February 17, 2011
New Mexico Environment Department
Hazardous Waste Bureau Chief
James Bearzi
james.bearzi@state.nm.us

The following comments are submitted to the New Mexico Environment Department for the **Sandia National Laboratories' Corrective Measures Implementation Report** (CMI Report) for the **Mixed Waste Landfill** that is a radioactive and hazardous waste dump contaminating Albuquerque's drinking water aquifer from its unlined pits and trenches.

The CMI Report should not be approved. The following issues have not been addressed:

Figure 1. Map of the Sandia Mixed Waste Landfill (Sandia MWL dump) showing the monitoring well network in 2007 of the six monitoring wells MW1 to MW6 and the background water quality well BW1 500 feet south of the dump.

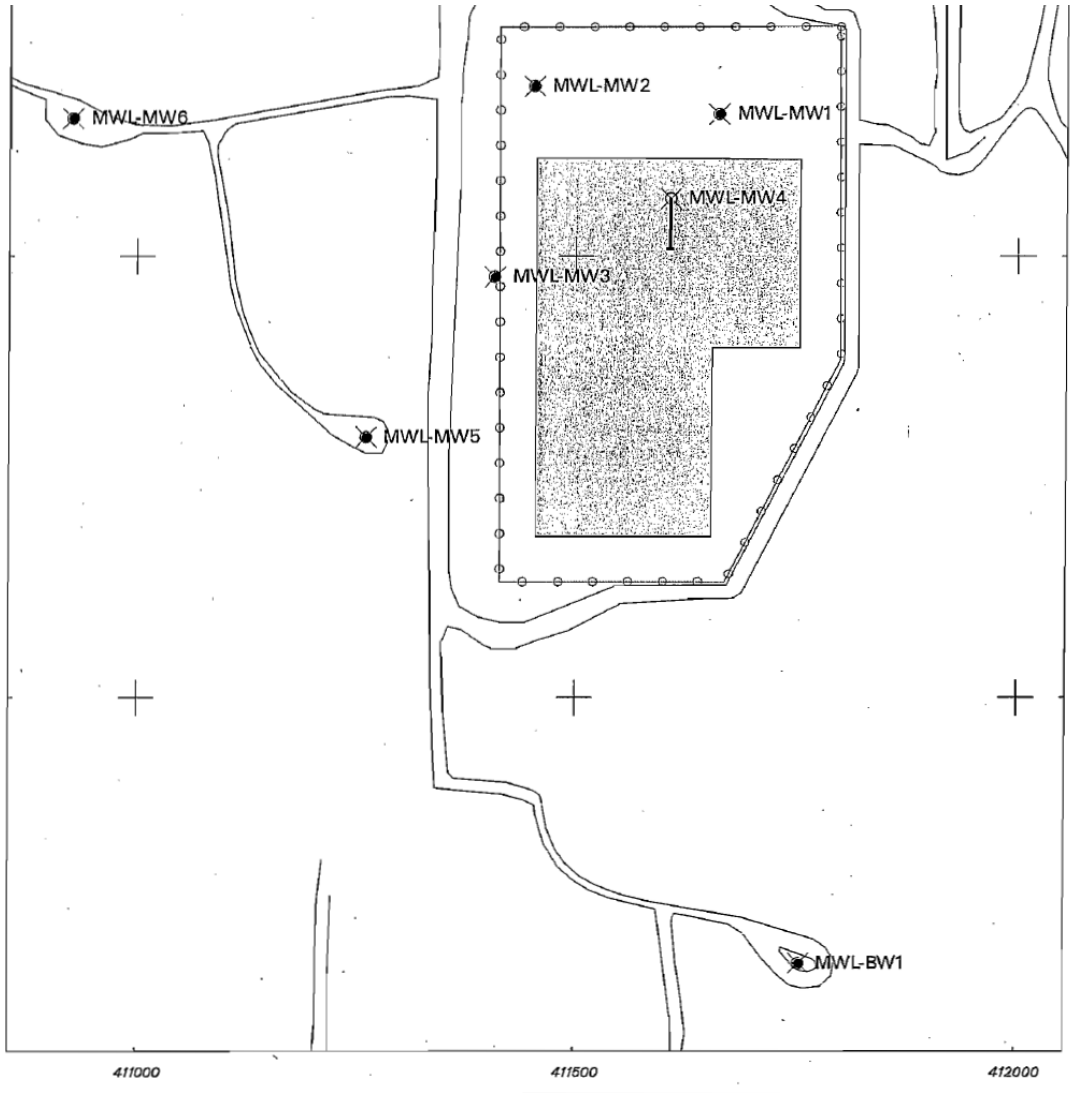
- The current monitoring well network at the Sandia MWL dump includes the six unreliable contaminant detection monitoring wells MWL-MW4, -MW5, -MW6, -MW7, -MW8 and -MW9 and the background water quality monitoring well MWL-BW2. The locations of the seven wells are shown on Figure 3 (see attached). The six contaminant detection monitoring wells in the current network require replacement because they do not meet the intended purpose to 1). monitor contamination at the water table below and downgradient from the MWL dump, 2). measure the elevation of the water table and 3). accurately determine the direction and speed of groundwater travel at the water table below and hydraulically downgradient from the MWL dump. The NMED HWB has not, but should enforce the requirement in the NMED Sandia Consent Order and RCRA for replacement of the six defective monitoring wells in the current network.

- Although NMED recognized that groundwater flow is to the southwest, no groundwater monitoring wells were installed to the south of the MWL dump in either the uppermost aquifer or at the water table. The dirt cover should not have been installed without adequate investigation to the south of the MWL dump.

Figure 2. Schematic of the Monitoring Wells and the Hydrogeologic Setting at the Sandia MWL dump. The permeable sands and gravels in the Ancestral Rio Grande "A" Deposits (ARG deposits) are the valuable groundwater resource for Albuquerque and the surrounding region.

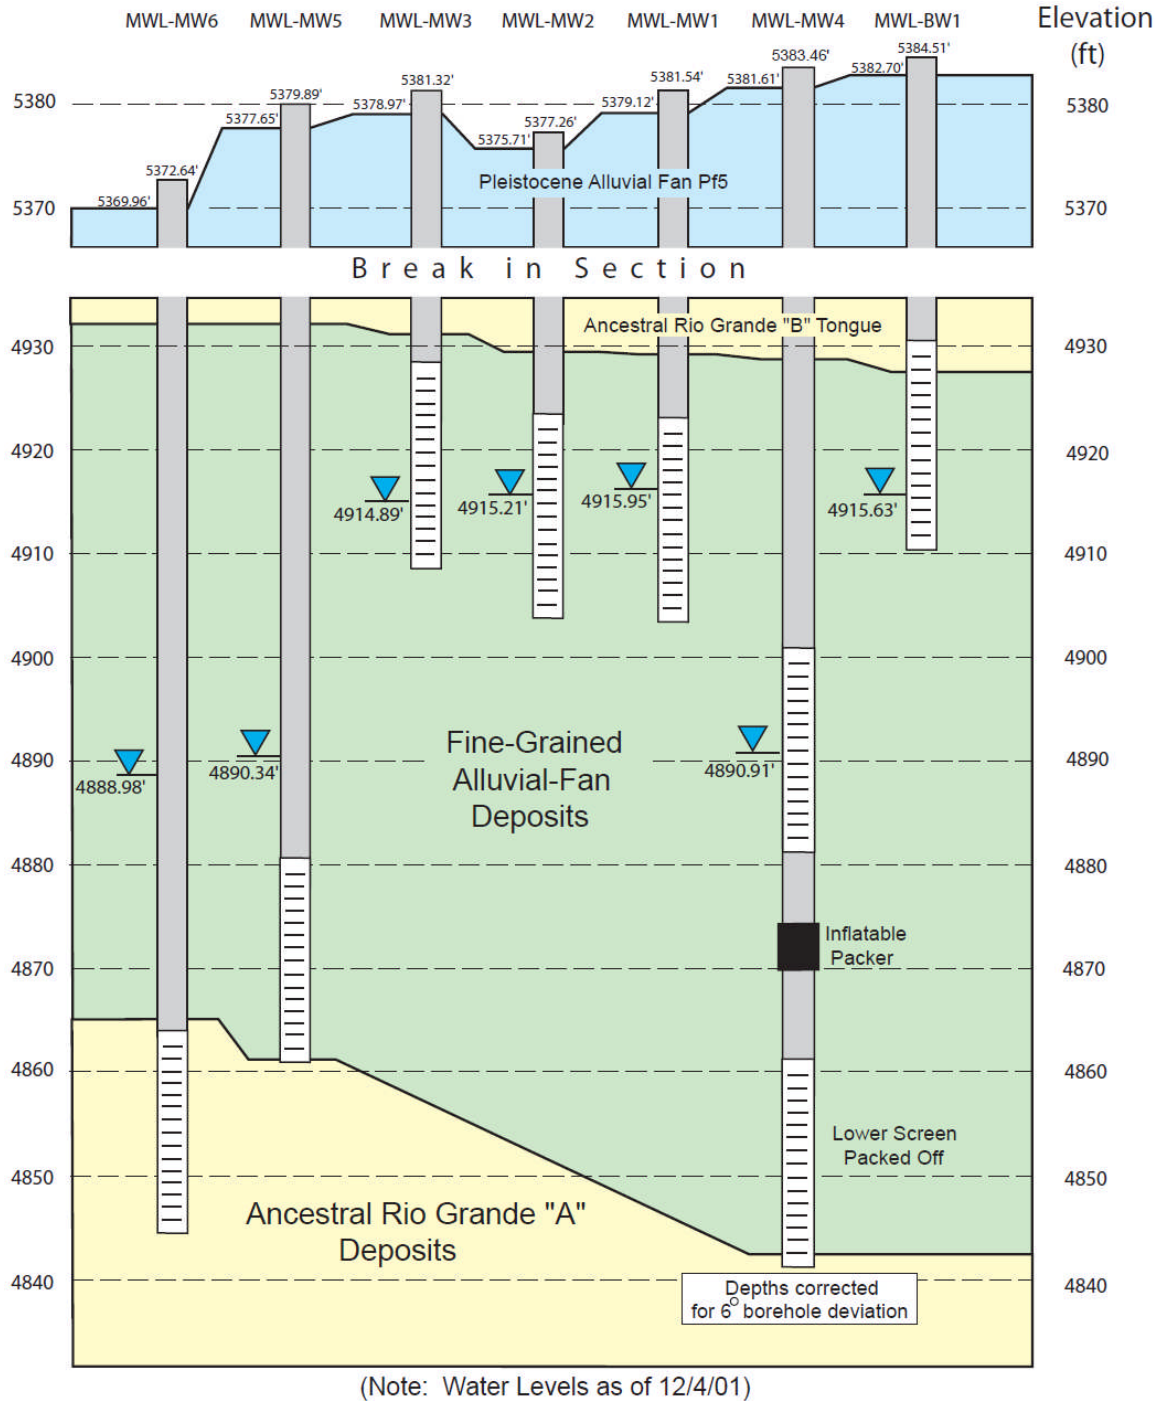
- There are two zones of saturation below the Sandia MWL dump that require networks of monitoring wells. A reliable network of monitoring wells was not installed in either of the two zones. Figure 2 (see attached) is a geologic cross section that shows

the two zones of saturation below the MWL dump that require networks of monitoring wells. The upper zone is the water table in the fine-grained alluvial fan sediments. The deeper zone is the Ancestral Rio Grande Deposits (ARG Deposits) that are below the layer of fine-grained alluvial fan sediments that form a leaky confining bed above the ARG Deposits.

Figure 3. Location of the new detection monitoring wells MWL-MW7, -MW8 and -MW9 along the western boundary of the Sandia MWL Dump and new background monitoring well MWL-BW2 200 feet east of the MWL Dump.

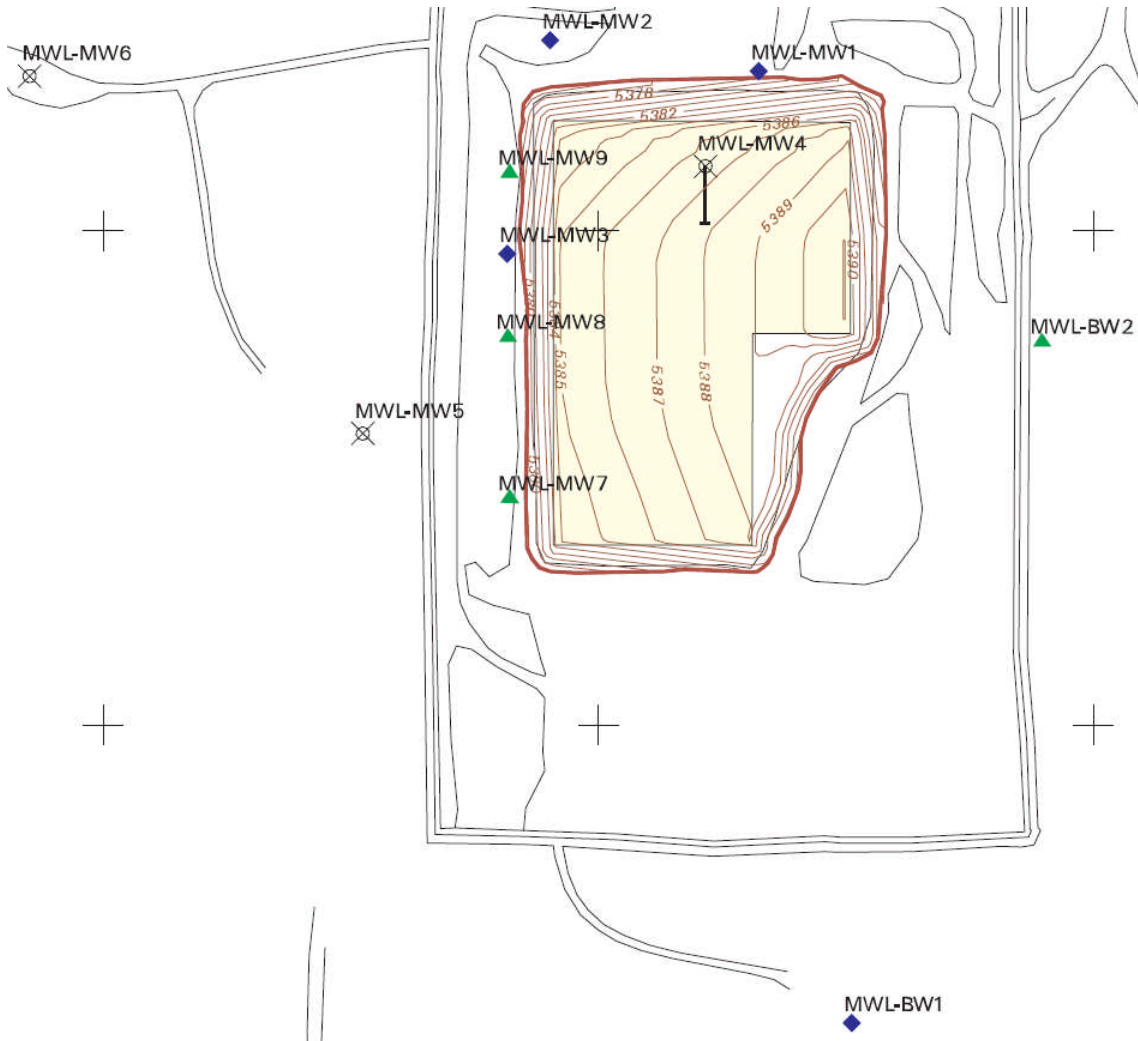
- Wells MWL-MW7, -MW8 and -MW9 – three wells installed in 2008 were drilled with improper methods with 30-ft screens installed too deep to detect contamination and measure the elevation of the water table below the MWL dump. Wells MWL-MW1, -MW2, -MW3, -MW4, -MW7, -MW8, -MW9 and -BW1 – the high-flow pumping methods purged the wells dry and highly aerated water samples were collected up to a week later. This sampling method removes volatile and trace metal contaminants from the collected water samples.
